**Report: TAB REPORT**  
**Function: Test, Adjust, & Balance**  
**Date: 04/05/2023**

**PROJECT**  
**03-27-23 FREDDY'S - JASPER, AL**

ERC Development, LLC

KEF2Conduit.jpeg

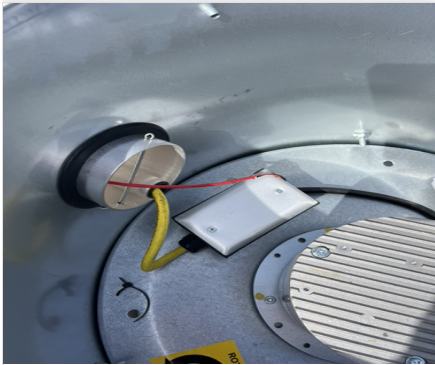
**Issue Name :** KEF2 wire is not ran through conduit

**Description :** Recommended to install conduit.
